19/01868 - Former The Little House Charters Road Sunningdale Ascot SL5 9QF

Details required by condition 5 (refuse and recycling) 6 (cycle parking) of planning permission 17/01066/VAR as approved under (15/03090) (allowed on appeal) for the redevelopment of site to provide 6 x 3 bedroom apartments

19/01868/CONDIT

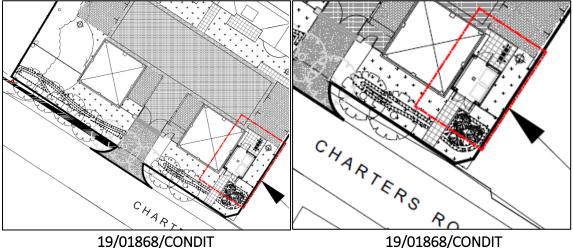
Firstly, the refuse and cycle storage location drawings accompanying 19/01868 appear to show an access footpath that extends from the double opening doors of the refuse location area to the front boundary with Charters Road. This is clearly visible in the drawings below.

However, the parish council could not see how this footpath might be accessed from Charters Road, if that was the intention, as no entrance is mentioned or drawn. Closer examination of an earlier withdrawn application -18/00862- shows a similarly positioned footpath from a bin storage area to Charters Road- as can be seen in the diagram below. But, also accompanying 18/00862 is a street scene showing an additional double door access in the boundary wall from Charters Road. The Parish Council cannot therefore

understand what is the purpose of this footpath shown in 19/01868. Only vegetation is shown either side of the length of the path so it appears to be a 'road to nowhere'.
